A HYDROGEOLOGICAL ASSESSMENT OF THE U.S. FOREST SERVICE/BUREAU OF LAND MANAGEMENT MOUNTAIN VALLEY PIPELINE AND EQUITRANS EXPANSION PROJECT SUPPLEMENTAL DRAFT ENVIRONMENTAL IMPACT STATEMENT DECEMBER 2022

January 24, 2023

Prepared by Pamela C. Dodds, Ph.D., Licensed Professional Geologist
Prepared for The Wilderness Society

Figure 2.0-5 – Excerpt from POD Appendix C-3 E&S Plan Sheets of Environmental Detail MVP-31, illustrating the groundwater drainage from the pipeline trench, with groundwater directed to the land surface beyond the ROW.

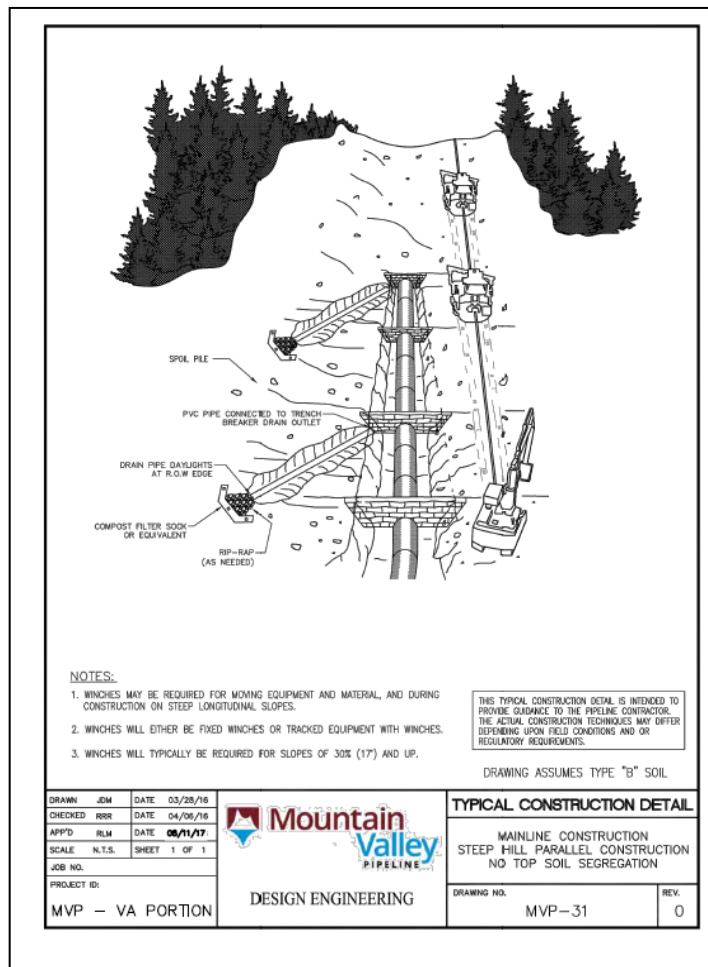
purposes, primarily to avoid collapse of the trench. As illustrated in **Figure 2.0-5**, water collects on the upslope side of the trench breakers is diverted to the adjacent land surface through drains. It is stated on page 6-12 of the MVP POD that "...trench drains will be installed on side slopes and steep slopes before the pipe is placed in order to channel water away ... and these drains will not be removed after construction is complete. These permanent drains will consist of perforated tile or pipe surrounded with rock (1-inch stone or similar, which may be taken from excavated spoils) that will terminate at a riprap pad near the edge of the ROW. These drainage controls are not removed after pipeline installation." Thus, groundwater continues to be removed after completion of construction activities.

Figure 3.0-1 – Excerpt from MVP POD Appendix C-3 E&S Plan Sheets of Environmental Detail MVP-ES4.2, illustrating the cut slope construction for the MVP ROW.

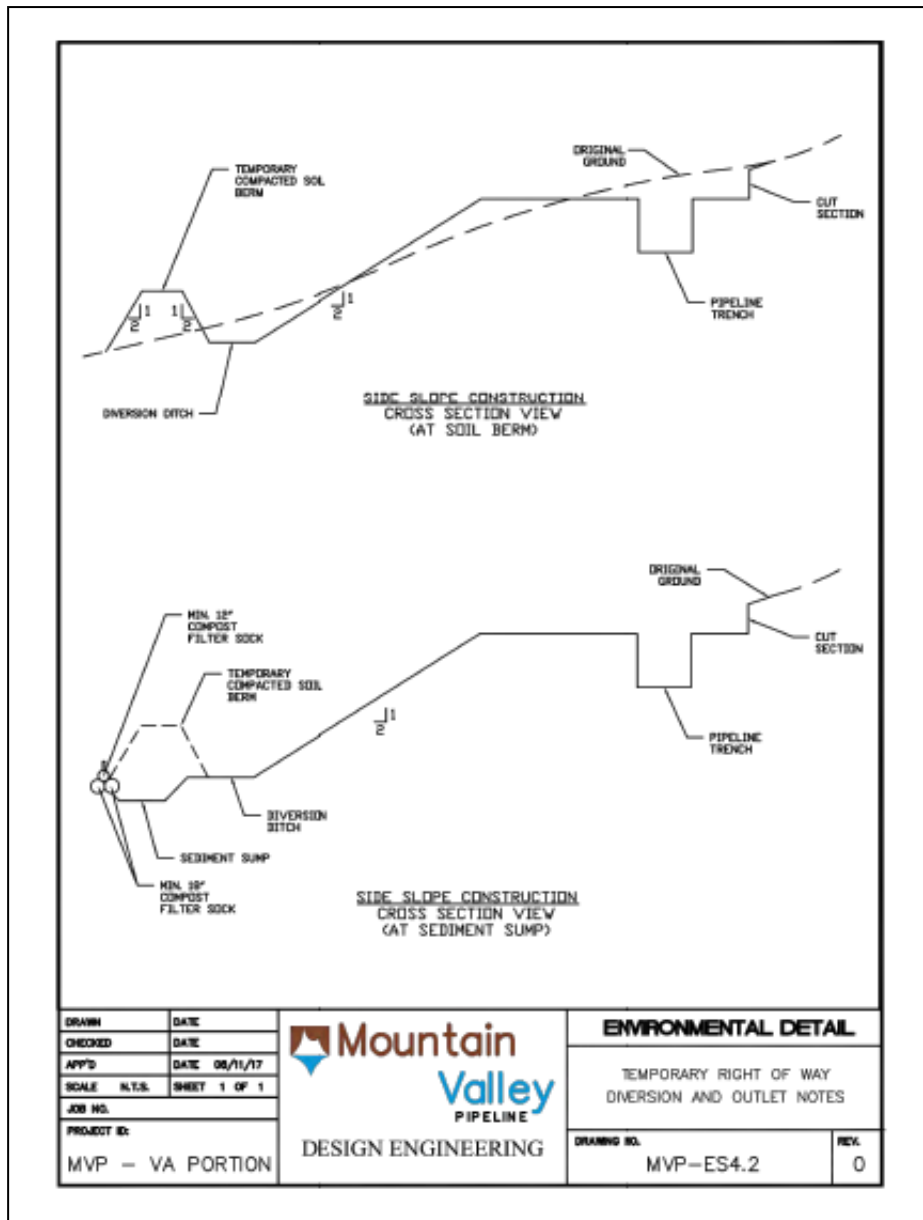
In the Geosyntec Report presented in Appendix B of the MVP POD, it is stated there are two situations in which the MVP ROW crosses the mountain ridges: the Transverse Profile Category and the Perpendicular Profile Category. The forested ridges where the MVP ROW is located in JNF function as headwater areas in watersheds of first and second order streams, providing protected areas of filtered light, cooler temperatures, and seeps and springs where the groundwater intercepts the ground surface. Aquatic species within these forested, protected areas constitute the base of the aquatic food chain for areas downslope and downstream. Where Transverse Profile crossings are located, not only is the protective forest removed, but the headwater aquatic habitats are dewatered and removed in order to establish a relatively level surface for the MVP ROW (**Figure 3.0-1**).

Figure 3.0-2 – Excerpt from MVP POD Appendix C-3 E&S Plan Sheets of Environmental Detail MVP-ES4.1, illustrating ridge leveling for construction in the MVP ROW.

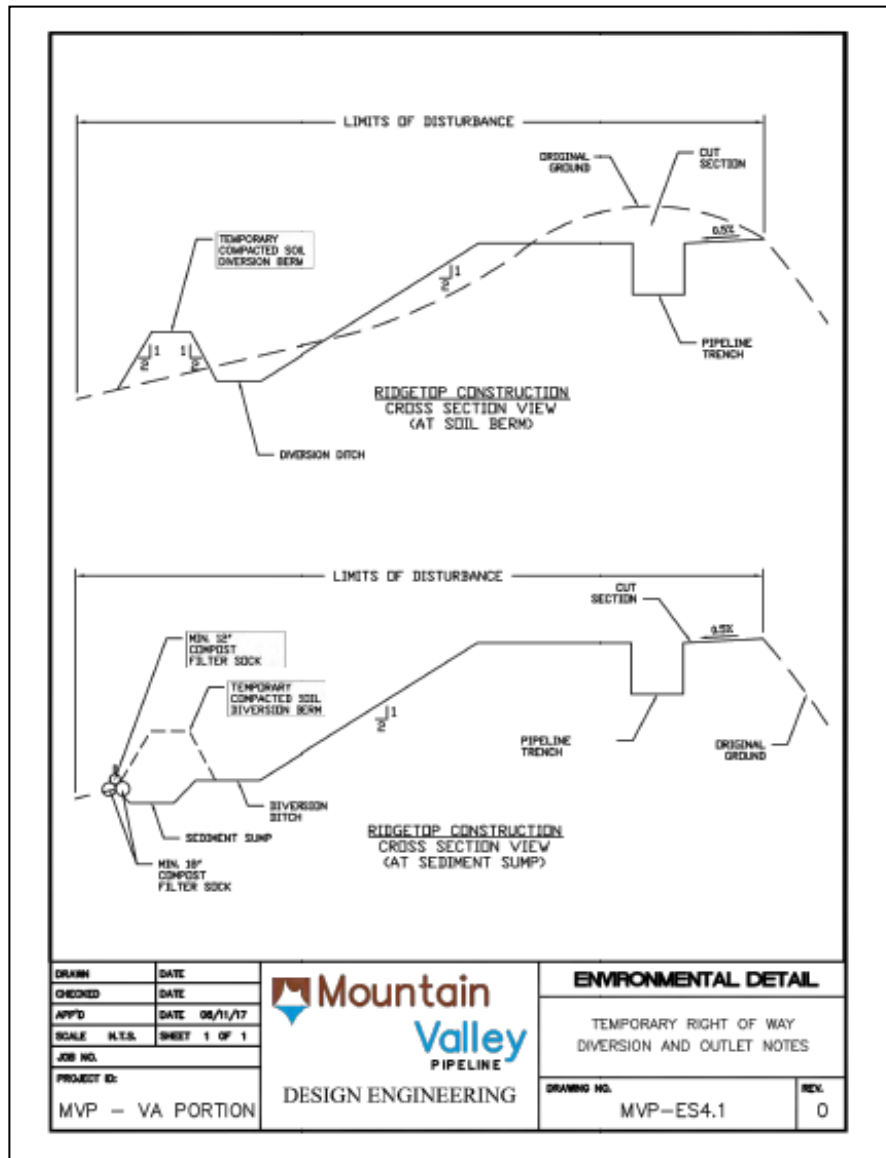
Where the Perpendicular Profile crosses the JNF ridges, the protective forest cover for headwater aquatic habitats is removed and the ridgeline is excavated to form a relatively level surface (**Figure 3.0-2**).

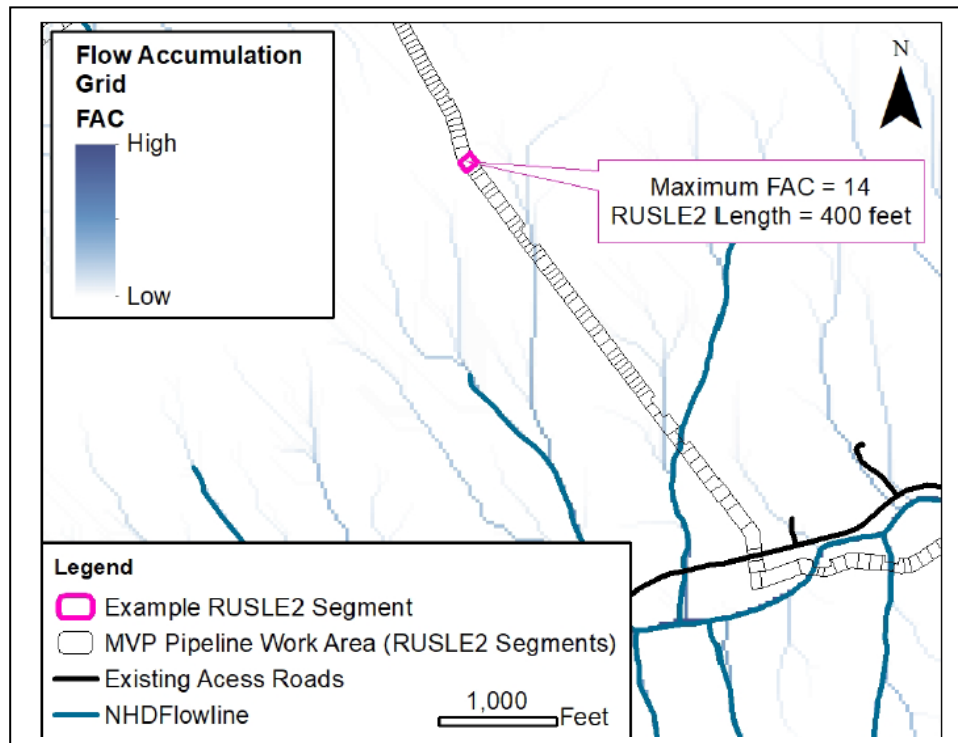
It is stated in the Geosyntec Report that the MVP ROW was **hydrologically disconnected (Figure 4.0-1) from the surrounding area in order to estimate sediment loss** using the Revised Universal Soil Loss Equation Version 2 (RUSLE2) and previous versions.

For the “RUSLE2 Example Analysis” (Appendix A, Geosyntec Report), the sample polygon (illustrated as 100 feet long by 125 feet wide, or 0.29 acre) is located between MVP ROW MP 218.6 and MP 218.8 in the Trout Creek-Craig Creek HUC 12 watershed. At this location, the MVP ROW crosses a functional first order stream watershed approximately 188 acres in size. The MVP ROW crosses a stream (identified in the FERC FEIS as S-PP22 with a spring and seep source). The MVP crossing this first order stream watershed is approximately 3 acres, which is 1.6 percent of this functional first order stream watershed. However, this acreage is only 0.009 percent of the Trout Creek-Craig Creek HUC 12 watershed. “Figure A-26: Baseline Scenario Sediment Delivery in tons/ac/year” (Appendix A, Geosyntec Report) provides that the baseline sediment delivery for the 0.29 acre example polygon is 0.3 tons/ac/year. “Figure A-27: Felled Scenario Sediment Delivery in tons/ac/year” (Appendix A, Geosyntec Report) provides that the felled sediment delivery for the 0.29 acre example polygon is 1.41 tons/ac/year. “Figure A-29: During Construction Scenario Sediment Delivery in tons/ac/year” (Appendix A, Geosyntec Report) provides that the during construction sediment delivery for the 0.29 acre example polygon is 24.54 tons/ac/year. The Virginia Department of Transportation estimates one ton (2000 pounds) of sediment to 1 cubic yard, or 27 cubic feet, of sediment for purposes of estimating the amount of sediment transported in trucks for fill material. This calculation is also available at: <https://www.gravelshop.com/gravel-calculator.asp?groupid=26&productid=412>. Using the during construction value of 24.54 tons/ac/year in the Geosyntec Report polygon example, this would be approximately 24.54 cubic yards/ac/year or 662 cubic feet/ac/year of sediment that would be released during construction of 0.29 acre within a functional first order stream watershed. There are approximately 24 polygons between MP 218.6 and 218.8 of the MVP ROW. The Geosyntec Report does not provide the amounts of tons/ac/year for each polygon in the information made available to the public; however, there would be impacts to the first order stream resulting from such amounts of cubic yards of sediment released to the headwater areas of the receiving stream. It is important to provide such meaningful information in order for the Forest Service to effectively evaluate the impact of sediment loss from the MVP ROW on “ecological integrity of riparian areas in the plan area, including plan components to maintain or restore structure, function, composition, and connectivity” in accordance with the 36 CFR 219 planning rule requirement § 219.8(a)(3)(i).
